1990 Corvette: Service Bulletin: SIR Diagnostics and Procedures to Prevent Codes 16 and 26 Due to Corrosion Revised

Subject: SERVICE MAN. UPDATE SEC.9J A/B REV. SIR DIAGNOSTIC PROCEDURE

Model and Year: 1990 CORVETTE

Bulletin Number: 90-436-9J - (11/07/1991)

FORWARD DISCRIMINATING SENSORS Figures 1 & 2 -----

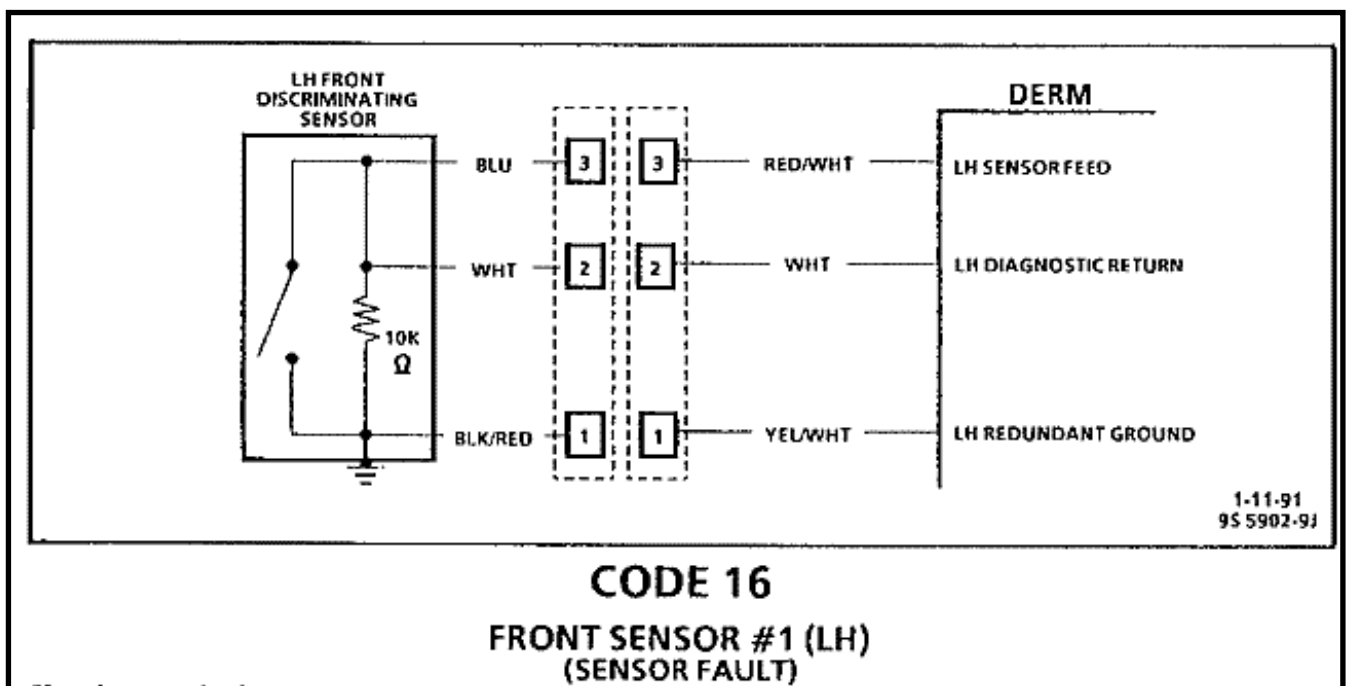
Caution should be used to assure proper location of sensors to the front frame rails. The keying of the sensors to the frame rails through the differently sized mounting bolt holes in the sensor mounting plate should never be modified in the field.

1. Apply a thin layer of special grease P/N 12345579 to the frame rail mounting surface and the mounting flange of the sensor. Do not apply the grease to the mounting bolts or holes.
2. Forward discriminating sensor, with arrow pointing toward front of vehicle.
3. External tooth lock washers, P/N 11501869 (8 mm) and 121753 (6 mm) to mounting bolts.
4. Sensor mounting bolts. Ensure that washers are between bolt head and sensor mounting flange, not between mounting flange and frame rail.

- Front (13 mm head) bolt to 25 N.m (19 lb. ft.) - Rear (10 mm head) bolt to 14 N.m (125 lb. in.)
5. Sensor electrical connection, then clip completed connection into retainer.
 6. ECM and support; refer to DRIVEABILITY AND EMISSIONS (SECTION 6E3).

CODE 16 FRONT SENSOR #1 (LH) (SENSOR FAULT)

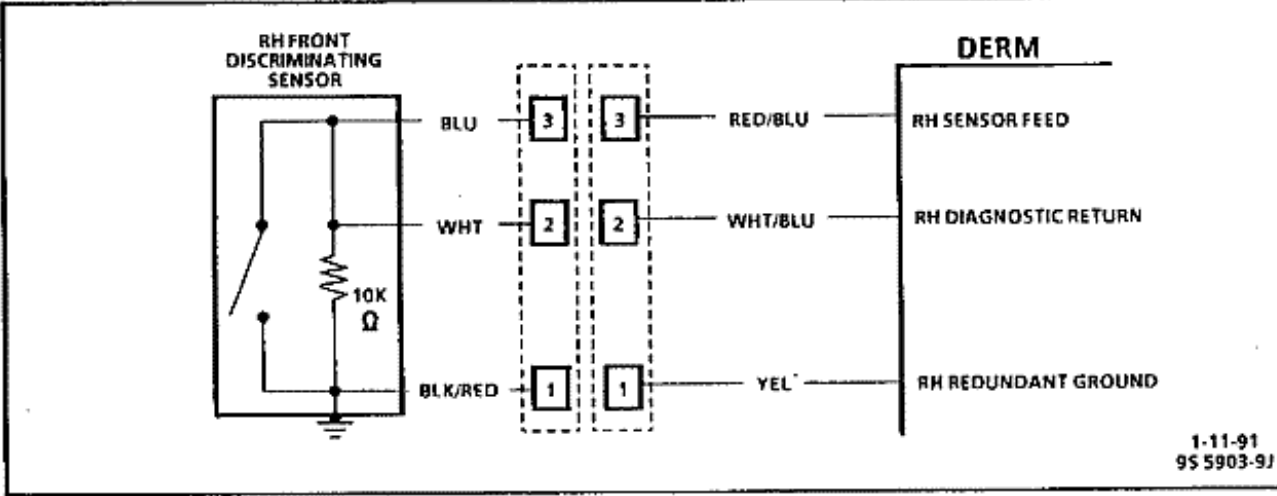
- 1
- IGNITION "OFF."
 - DISCONNECT SENSOR CONNECTOR.
 - USING ADAPTERS FROM J 37808-10 AND DVM J 34029-A OR DVM J 39200, MEASURE THE RESISTANCE BETWEEN TERMINALS IN THE SENSOR PIGTAIL CONNECTOR AS SHOWN BELOW. NOTE MEASUREMENTS FOR EACH CHECK.

SENSOR TERMINALS	RESISTANCE
1 AND 2	ABOUT 10,000 Ω
1 AND 3	ABOUT 10,000 Ω
2 AND 3	LESS THAN 1 Ω

- 3
- REMOVE SENSOR; REFER TO "LEFT SENSOR" ON ATTACHED PAGES.
 - CLEAN ANY PAINT AND/OR CORROSION FROM SENSOR AND FRAME RAIL MOUNTING POINTS AND MOUNTING BOLTS.
 - INSTALL SENSOR; REFER TO "LEFT SENSOR" ON ATTACHED PAGES TO APPLY SPECIAL GREASE AND LOCK WASHERS UPON INSTALLATION TO HELP PREVENT RECURRENCE OF CODE 16 DUE TO CORROSION.
 - CLEAR CODES (TECH 1 PREFERRED).
 - IGNITION "OFF," THEN "ON."
 - DOES CODE 16 RESET?

- 4
- REMOVE SENSOR; REFER TO "LEFT SENSOR" ON ATTACHED PAGES.
 - CLEAN ANY PAINT AND/OR CORROSION FROM FRAME RAIL MOUNTING POINTS AND MOUNTING BOLTS.
 - INSTALL NEW SENSOR; REFER TO "LEFT SENSOR" ON ATTACHED PAGES TO APPLY SPECIAL GREASE AND LOCK WASHERS ON INSTALLATION TO HELP PREVENT RECURRENCE OF CODE 16 DUE TO CORROSION.
 - CLEAR CODES (TECH 1 PREFERRED).
 - IGNITION "OFF," THEN "ON."
 - DOES CODE 16 RESET?
